**THE  
NATIONAL  
BOARD**  
OF BOILER AND  
PRESSURE VESSEL  
INSPECTORS

# **NATIONAL BOARD SUBGROUP INSTALLATION**

## **MINUTES**

Meeting of July 14, 2015  
Columbus, OH

**FIGURE 3.7.5.1-c**  
**HOT-WATER BOILERS IN BATTERY — ACCEPTABLE PIPING INSTALLATION**

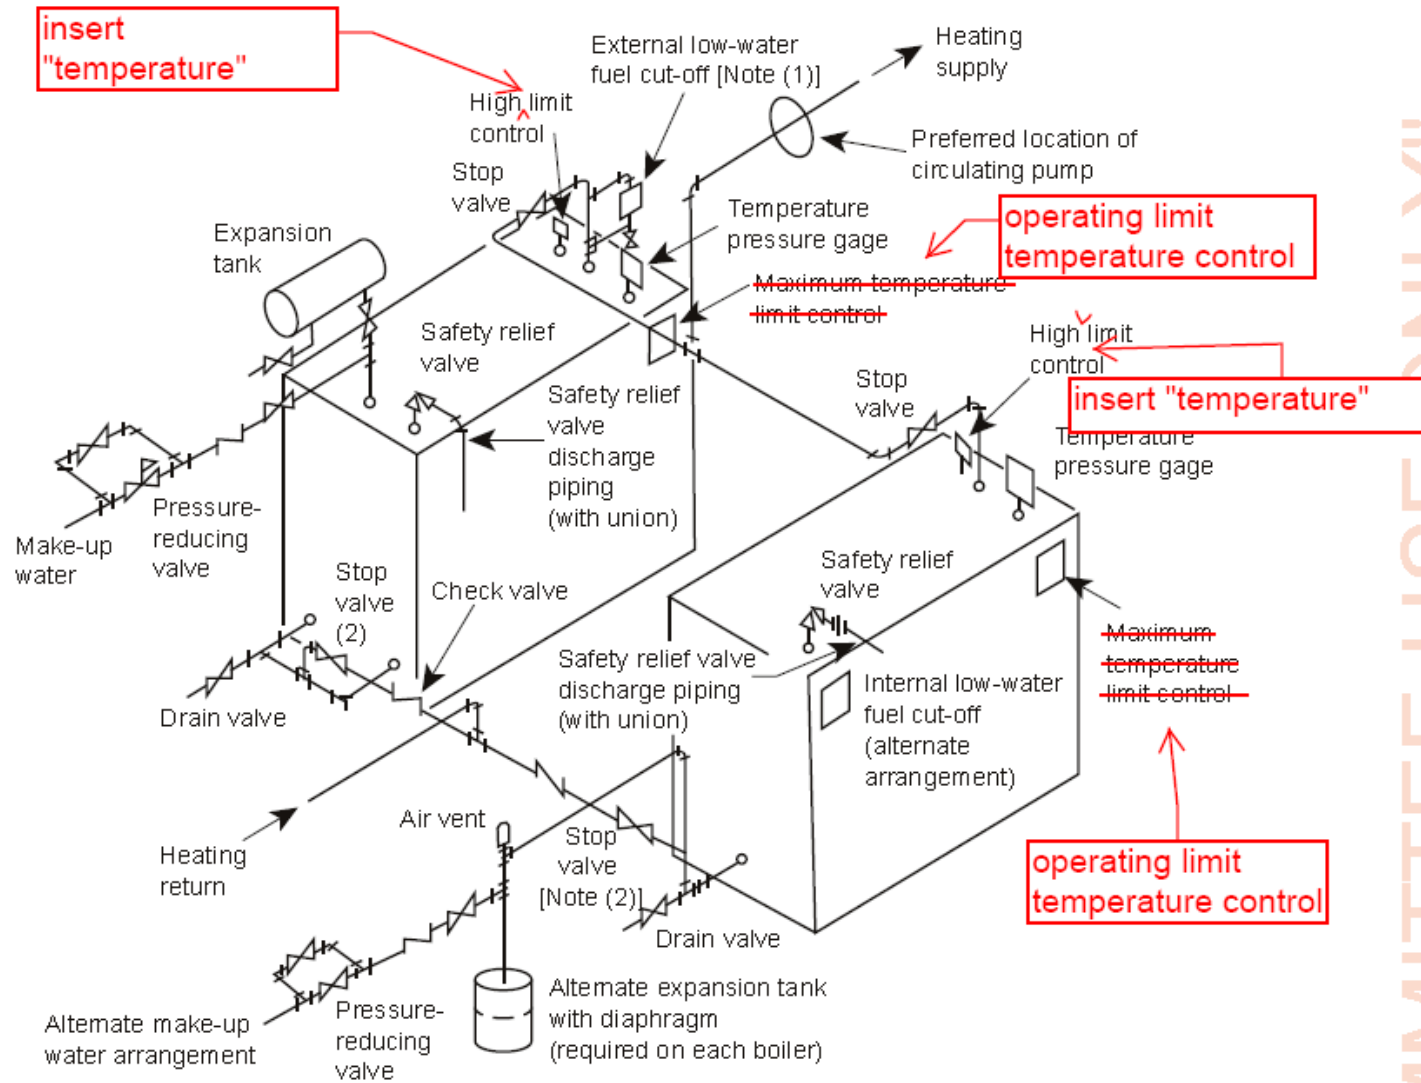
***NOTE — Paragraph (a) above describes an operating control, while (b) describes a temperature limit control. See Figure 3.7.5.1-c.***

Part 1 Section 3.8.2.3 text and Figure 3.7.5-c callouts do not agree with each other and do not agree well with ASME Section IV HG-613 or ASME CSD-1 CW-400 in the labeling of operating temperature controls and high limit temperature controls.

The descriptive language among the NBIC, CSD-1, and Section IV are similar but not identical. The Figures in the NBIC and Section IV are in harmony. The figures do not, however, match the text. A similar suggestion to correct the callouts has been made to Section IV.

**Figure HG-703.2**  
**Hot Water Boilers in Battery - Acceptable Piping Installation**

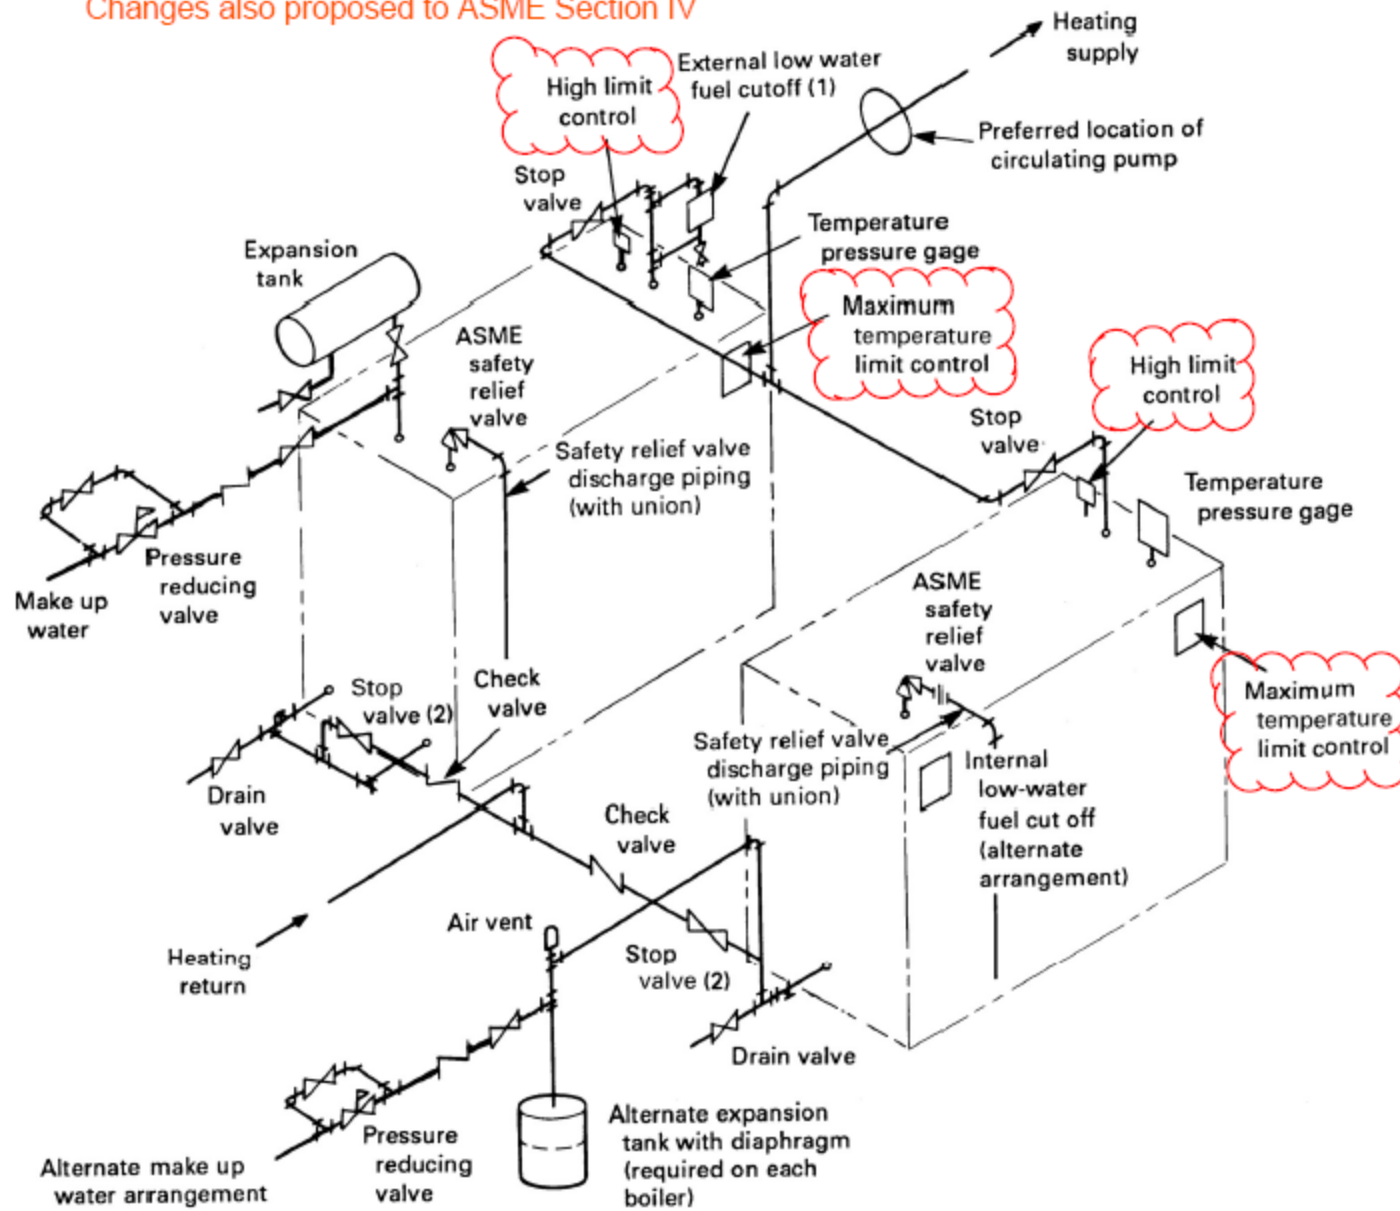
Changes also proposed to ASME Section IV
